**Oak Ridge High School
WELDING CLASSROOM RENOVATION
Job Number: 22023**

**ADDENDUM No. 1
April 5, 2023**

1 DEMOLITION FLOOR PLAN
AD101 1/8" = 1'-0"

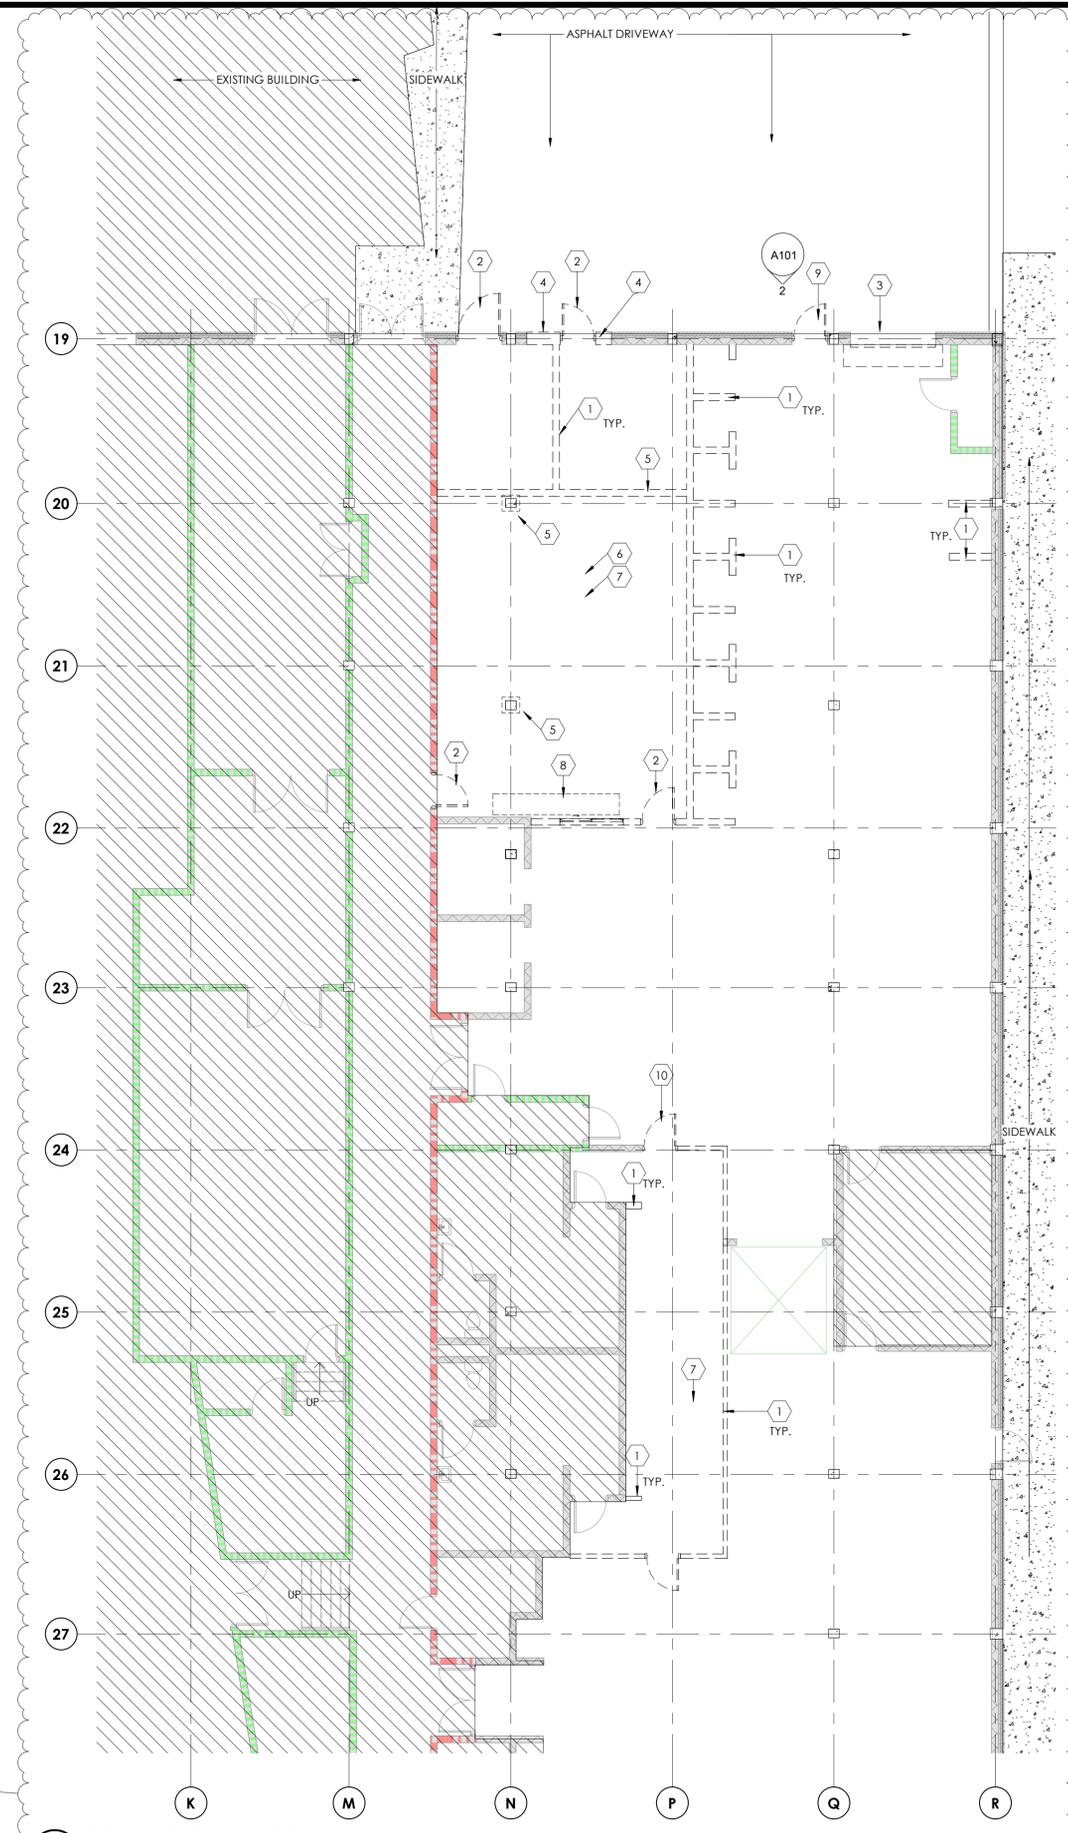
- 1. Addition of Key Notes.
 - 2. Revisions to demolition scope.
 - 3. Addition of “Demolition Elevation”.
- 1.6 Sheet A101 – NEW CONSTRUCTION
 - A. The attached drawing has been revised and is hereby formally RE-ISSUED due to but not limited to the following:

1 FLOOR PLAN
A101 1/8" = 1'-0"

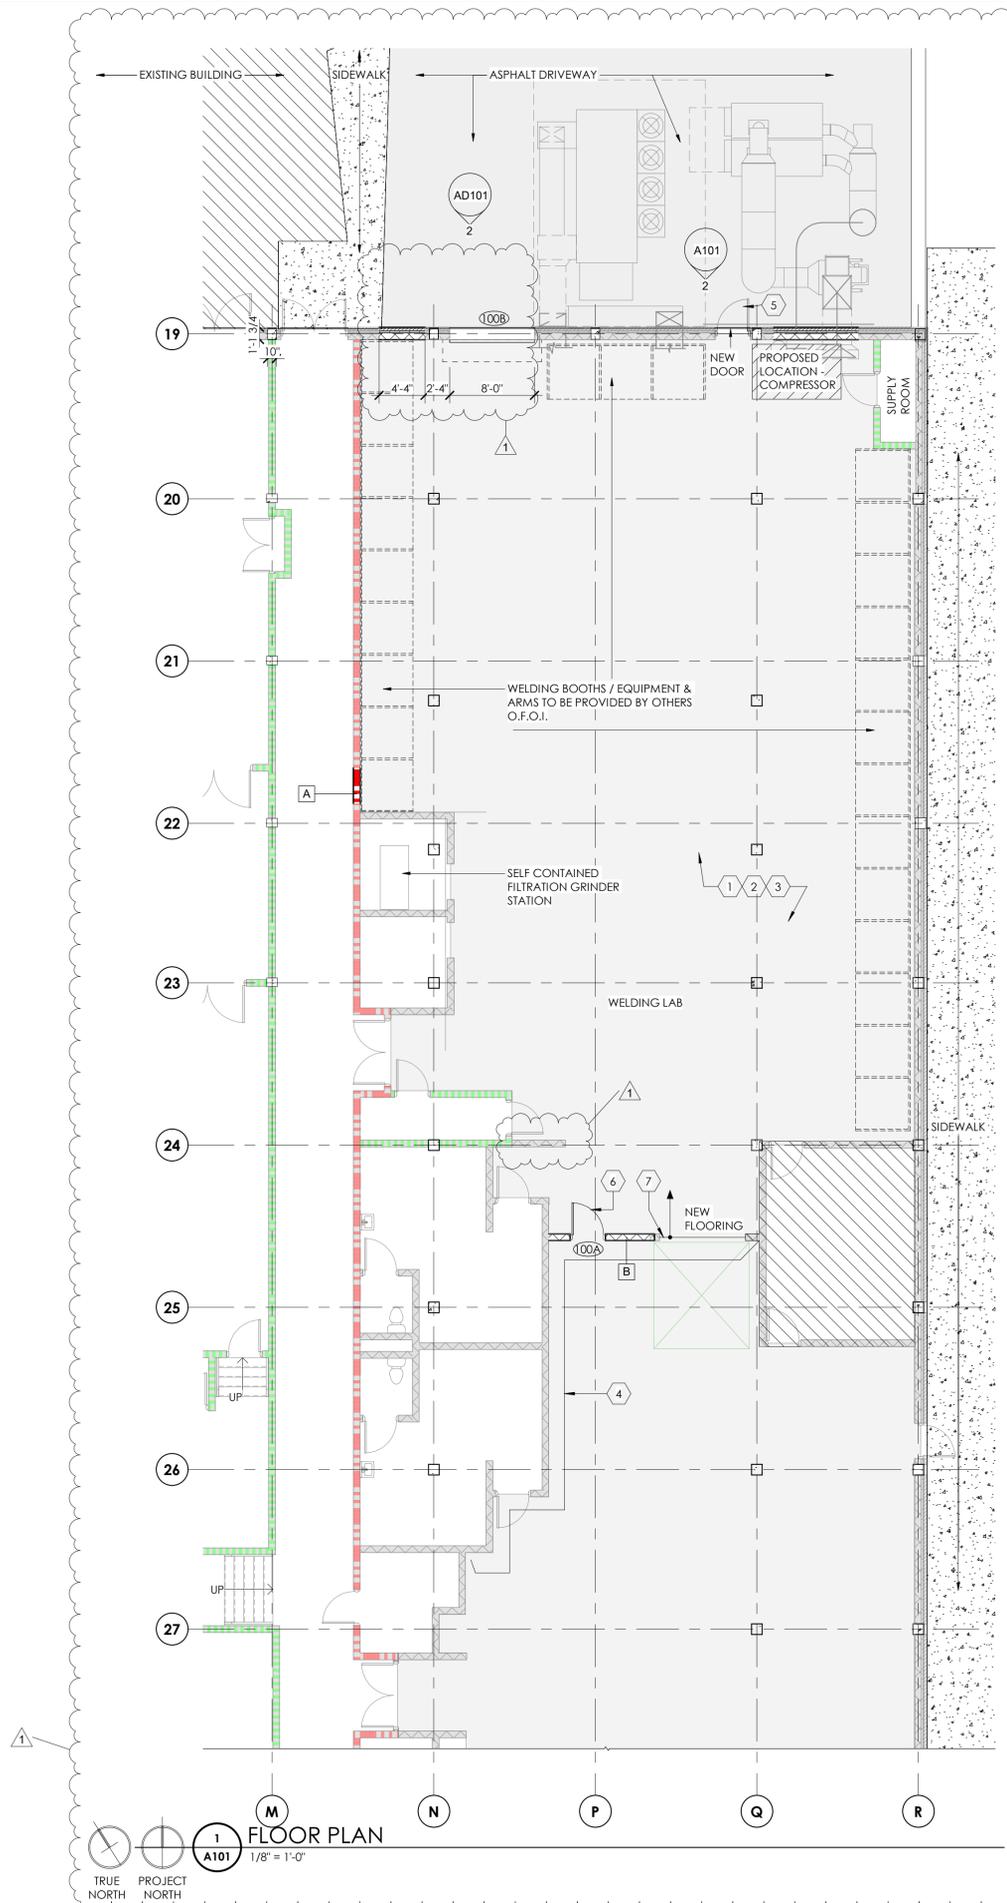
- 1. Addition of “Drawing Key Notes” to address finishes and clarification of scope.
 - 2. Revision of “Wall Rating Legend”.
 - 3. Revisions to “Floor Plan”.

- 4. Revisions to “Exterior Elevations”
 - 5. Addition of detail drawings.
- 1.7 Sheet A300 – REFLECTED CEILING PLAN

1 REFLECTED CEILING PLAN
A300 1/8" = 1'-0"

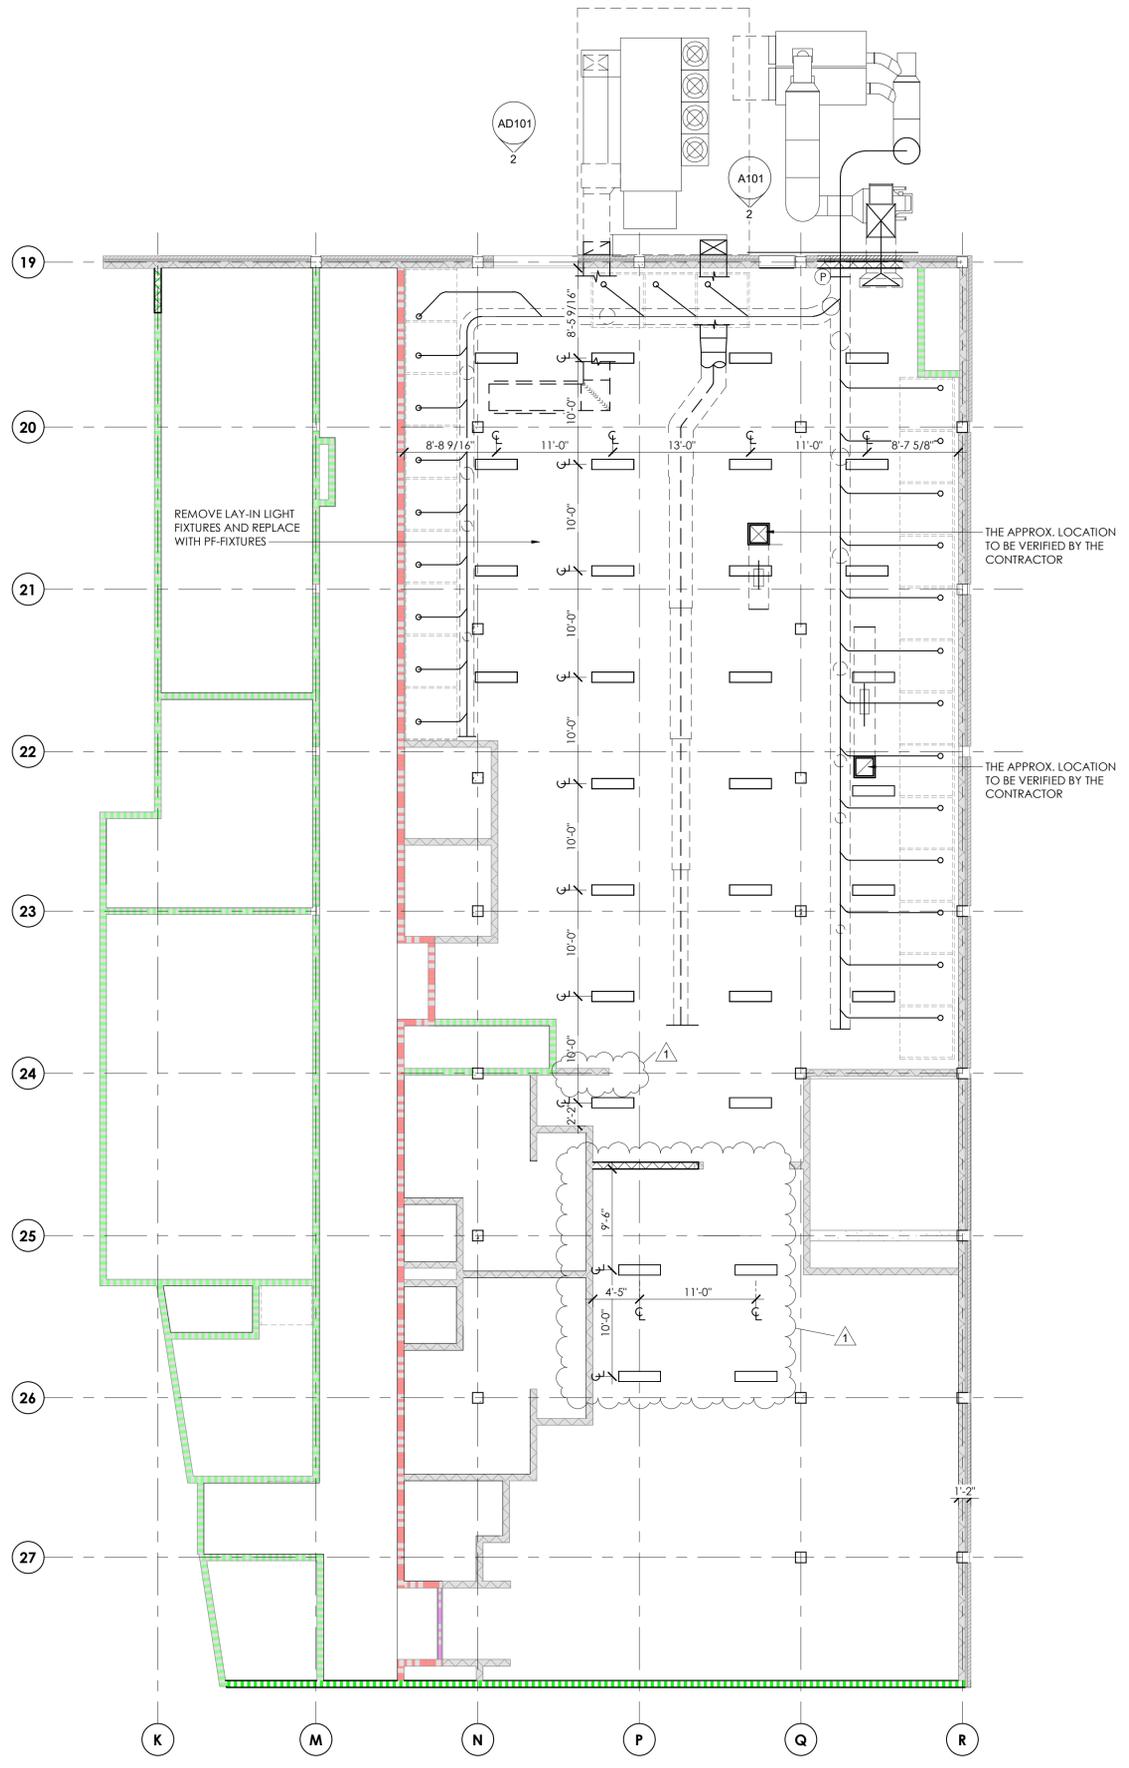
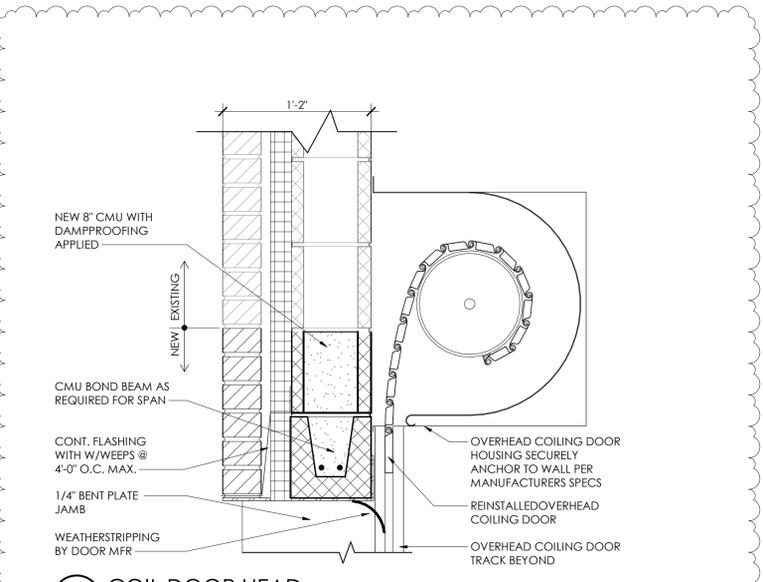
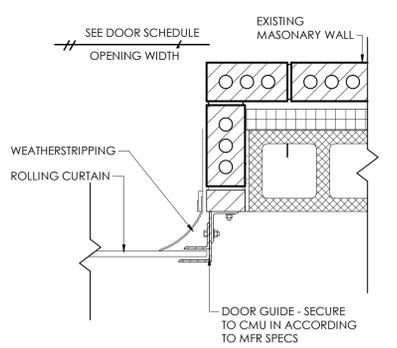
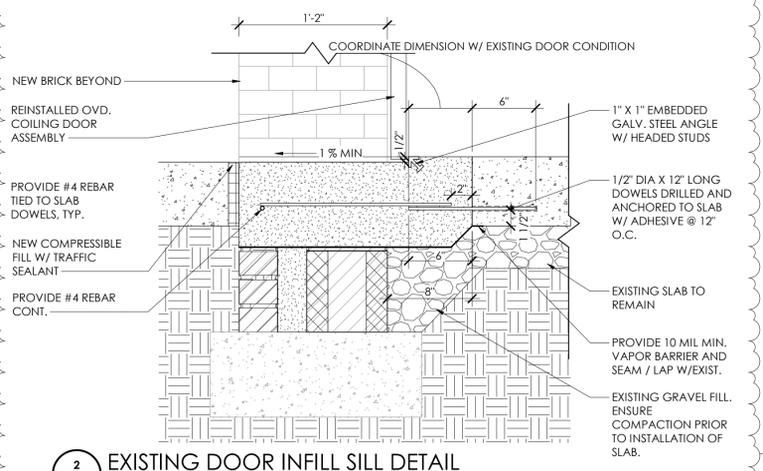
- A. The attached drawing has been revised and is hereby formally RE-ISSUED due to but not limited to the following:
 - 1. Addition and revision of detail drawings.
 - 2. Dimensions added to plan.

M100

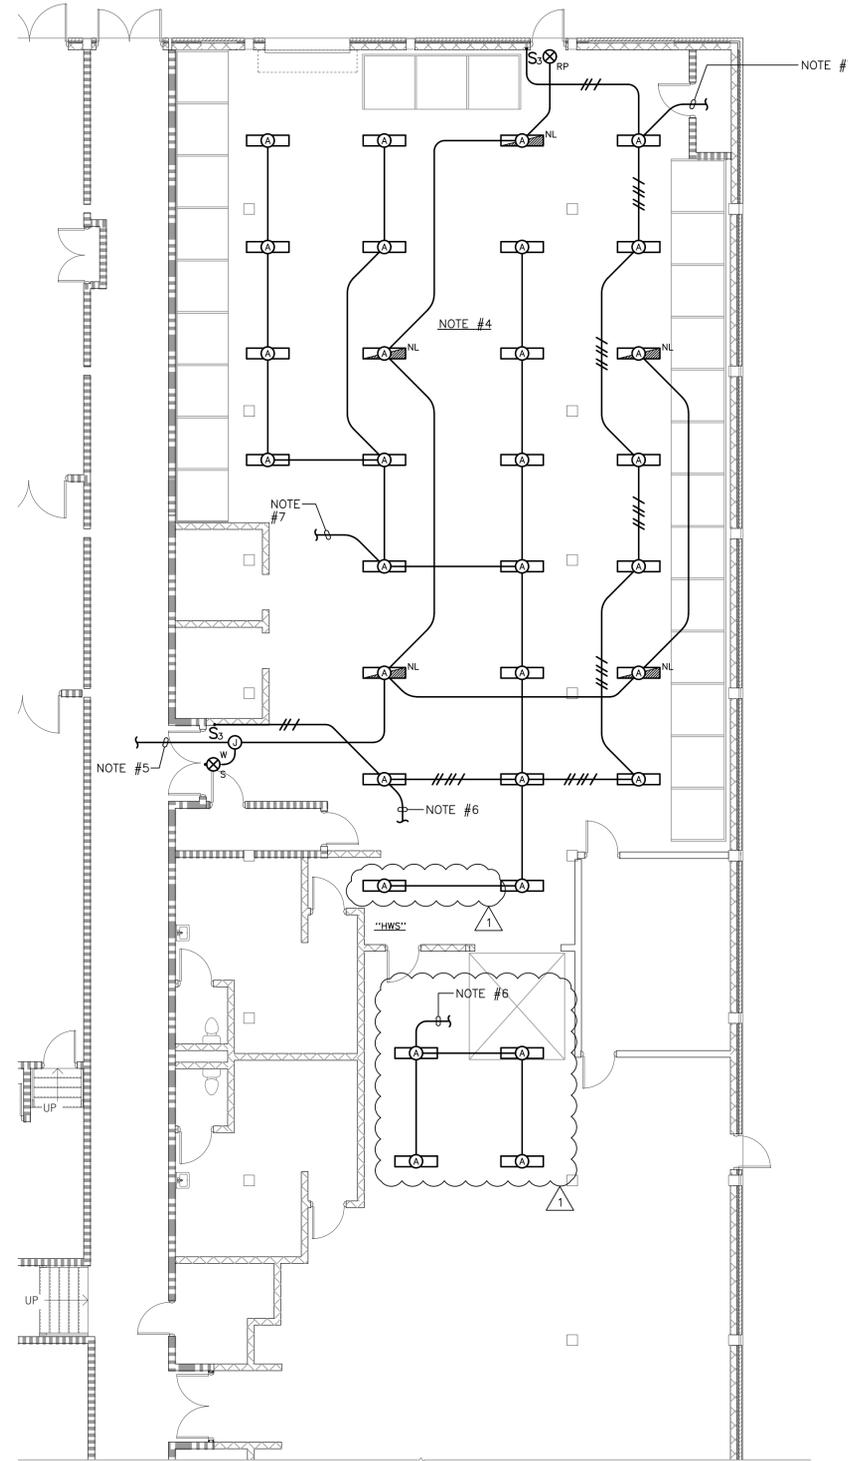
- 1.8 Sheet M100 – FLOOR PLAN – HVAC & GAS**
 - A. The attached drawing has been revised and is hereby formally RE-ISSUED due to but not limited to the following:
 - 1. Addition of plumbing scope.

DWG NO. **E101**

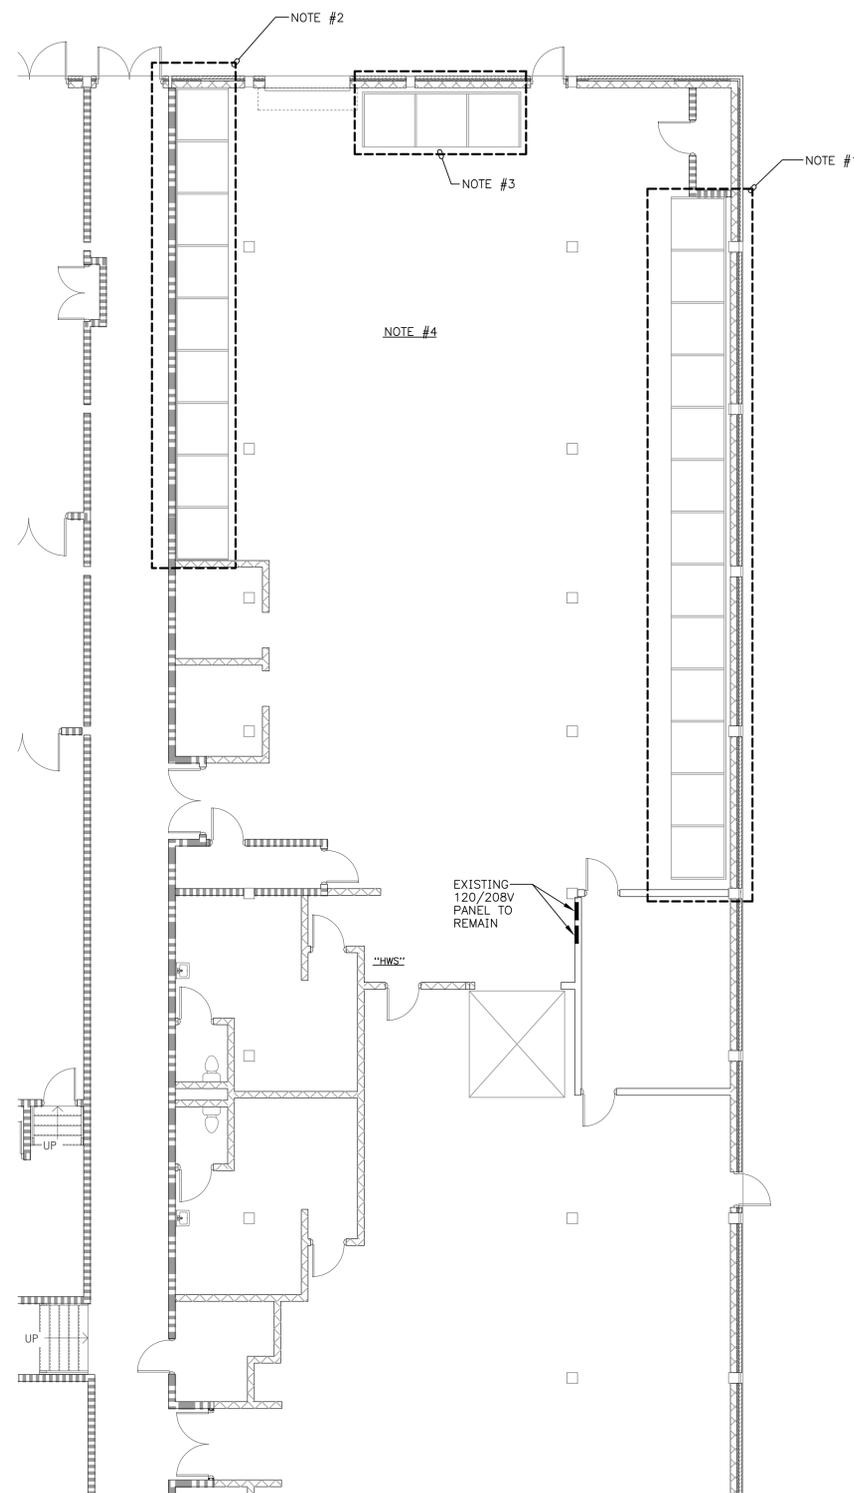
- 1.9 Sheet E101 – FLOOR PLAN - LIGHTING**
 - A. The attached drawing has been revised and is hereby formally RE-ISSUED due to but not limited to the following:
 - 1. Addition of light fixtures.
 - 2. Revision to “Wall Rating Legend”.

NOTES:
1. PANEL HWS SCHEDULED ABOVE WILL BE FURNISHED BY OWNER AND INSTALLED BY CONTRACTOR.

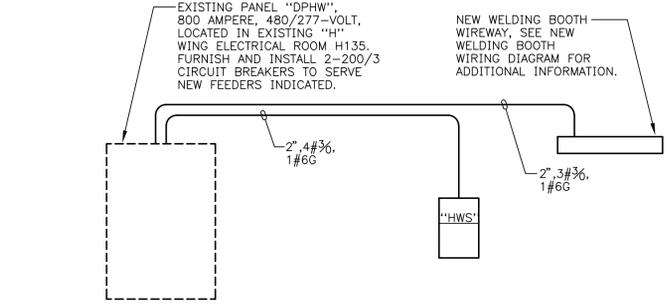
- 1.12 Sheet E201 – LEGEND AND SCHEDULES**
 - A. The attached drawing has been revised and is hereby formally RE-ISSUED due to the following:
 - 1. Clarification of “Panel HWS”.
